MEMORANDUM

Subject	Bright Tank Brewing Serpentine – Response to Shire & Referral Agency Feedback
Date	2 August 2022
Reference	22/014
To	Ashwin Nair, Shire of Serpentine Jarrahdale
From	Jesse Dunbar, Taylor Burrell Barnett Kelly Lavell, WaterInsight

Following the Shire's initial assessment of the development application for the proposed Restaurant and Brewery at 1248 Karnup Road, Serpentine, the Shire issued a further information request on 27 May 2022, with various referral agency comments provided subsequently. The following tables set out the various comments received, and the applicant responses to enable the Shire's assessment of the proposal.

venue // entry level plan proposed
1:400 1:125

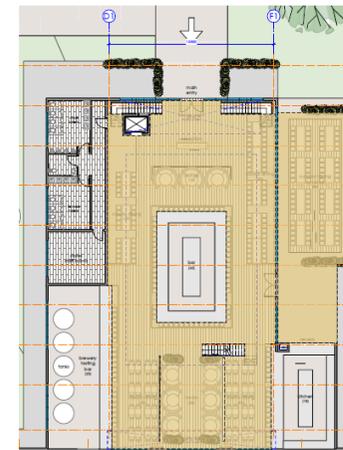
In terms of parking requirements under the draft Shire of Serpentine Jarrahdale Local Planning Scheme No.3, the submitted application is silent on providing an assessment against the parking requirements listed within the documents.

The Shire requires the assessment to be included in the planning report. The information must include the areas designated for dining, drinking and/or lounge areas and assembly areas so the Shire can confirm the parking requirements under draft LPS 3.

The proposed restaurant includes approximately 983.5m² of dining, drinking and/or lounge areas (as depicted on the plans below), with no public assembly areas.

This equates to a parking requirement of 246 bays under draft LPS3.

A total of 251 parking bays are provided on site, compliant with the requirements of draft LPS3.
